Subject: **Arbor Preserve North and South Planned Unit Development Final Site Plan Review**  
 Approximately 106.5 acres total, zoned PUD, Planned Unit Development

Description of Application:	The applicant is proposing to construct two single-family developments, with a total of 107 units, along with associated improvements.
Site Location:	Total of eight (8) existing parcels in Section 1 of Lodi Township, north of Waters Road and east of Wagner Road Parcels # M-13-01-300-007, M-13-01-300-008, M-13-01-300-009, M-13-01-300-010, M-13-01-300-005, M-13-01-300-011, M-13-01-300-012, M-13-01-300-014
Applicant:	Toll Brothers 26200 Town Center Drive, Suite 200 Novi, MI 48375
Current Zoning:	PUD, Planned Unit Development
Plan Date:	January 27, 2025

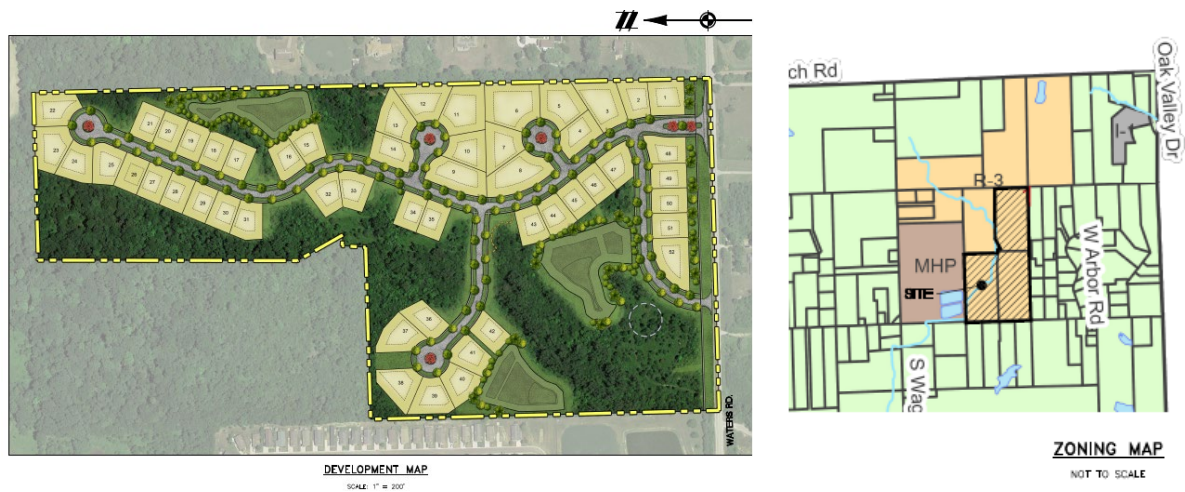
**2. Area and Bulk.** The proposed final site plan was reviewed in accordance with the standards for the R-3, Low-Density, Multiple-Family Residential District in *Section 30.101 Table of Dimensional Standards by District*, as well as the standards approved with the PUD and consent judgment. When a project is developed as a planned unit development (PUD), deviations from the ordinance standards are permitted to develop a plan that creatively uses the land, preserves natural features, and limits impervious surfaces. It should be noted that a number of deviations were approved as part of the PUD for the project and thus were recorded as part of the consent judgment. The table below reflects the ordinance requirement, as well as any deviations approved as part of the PUD/consent judgment.

<u>SOUTH</u> 2 story, 25-ft.	
<b>Lot Coverage</b>	30%	<u>NORTH</u> 22± %	In compliance for individual lots.  Data provided is for typical individual lot.  <b><i>Section 42.301 specifies that the maximum lot coverage in a PUD shall not exceed 25%. The applicant should provide total lot coverage for developments.</i></b>
		<u>SOUTH</u> 22± %

- a. The proposed preserved open space in both developments differs from that approved as part of the area plan/preliminary site plan. It should be noted that the proposed preserved space in Arbor Preserve South is more than previously proposed. The proposed preserved open space in Arbor Preserve North is less than previously proposed. **The amended consent judgment states that in no event shall modifications involve any material change to overall amount of open space areas, unless specifically approved by the Township Board. The open space shall be revised or Township Board approval is required.**

- 5. Water & Wastewater Systems.** The development proposes a community wastewater treatment system, one for each development, which is addressed by the amended consent judgment. **A detail is included in the plans for the WWTP (wastewater treatment plant) drive and parking area. The site plans should show proposed access drive and parking for the wastewater facilities. The plans should also indicate if any fencing and/or landscaping is proposed around the wastewater treatment facility.**

**12. Easements.** The existing conditions plans indicate a 66 ft.-wide ingress and egress and utility easement in the Arbor Preserve South development providing access to Parcel M-13-01-300-013, which is not included in the development plan. **As proposed, it appears the development has improvements within that easement, including private roads and building footprints. The plans shall be revised to accommodate this easement or the applicant shall provide materials showing the easement has been renegotiated with the property owner.**

1. Arbor Preserve North: Of the wetlands proposed to be preserved, unit buildable footprints are within the setback area, and the indicated wastewater treatment facility area is proposed within the wetland boundary and the setback area.
2. Arbor Preserve South: Of the wetlands proposed to be preserved, multiple buildable footprints appear to be within the building setback, driveways and sidewalks within the 25-foot setback.
